# Access Compliance Report

## Public Rights-of-Way

### (Curb Ramps)

Intersection ID: 42470	Main Street: DUKE_LANCASTER_DR	Cross Street: CASTLE_WATCH_AV	Location: NE
ADA ID: 2B002F97E153	Ramp Type: PerpDiag	Initial Pass/Fail: Fail	Overall Compliance: No
		Severity Score: 55

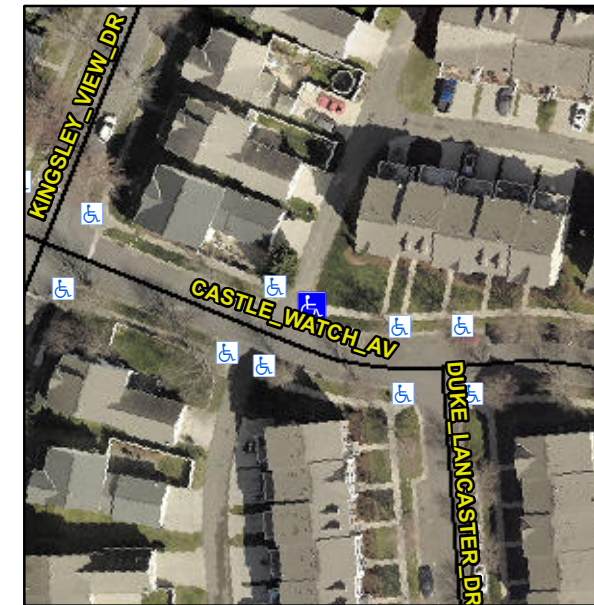
**Not Found, R304.5.1, R304.5.3**

Compliance	Description	Data	Compliance	Description	Data
N/A	Ramp Length (in)	189.5	Yes	Ramp Slope (%)	13.4
No	Ramp Width (in)	33.0	No	Ramp XSlope (%)	5.4
N/A	Flare Type LT	N/A	N/A	Flare Type RT	N/A
N/A	Flare Slope LT (%)	N/A	N/A	Flare Slope RT (%)	N/A
N/A	Flare Traversable LT?	N/A	N/A	Flare Traversable RT?	N/A
N/A	Landing Length (in)	N/A	N/A	DWS Provided?	N/A
N/A	Landing Width (in)	N/A	N/A	DWS Contrast?	N/A
N/A	Landing Slope (%)	N/A	N/A	DWS Length (in)	N/A
N/A	Landing X Slope (%)	N/A	N/A	DWS Full Width?	N/A
N/A	Landing Curb? (Y/N)	N/A	N/A	DWS Offset (in)	N/A
N/A	Shared Landing?	N/A			
N/A	Gutter Ponding?	N/A	N/A	Gutter Slope (%)	N/A
N/A	Gutter Lip Ht (in)	N/A	N/A	Gutter X Slope (%)	N/A
N/A	Painted X Walk1?	No	N/A	Painted X Walk2?	No
	X Walk 1 Direction	To NW		X Walk 2 Direction	To SW
N/A	X Walk 1 Width (in)	N/A	N/A	X Walk 2 Width (in)	N/A
	X Walk 1 Slope (%)	2.5		X Walk 2 Slope (%)	0.3
	X Walk 1 X Slope (%)	1.9		X Walk 2 X Slope (%)	2.6

**Remove & Replace Curb Ramp With Two New Directional Ramps or Equivalent.**
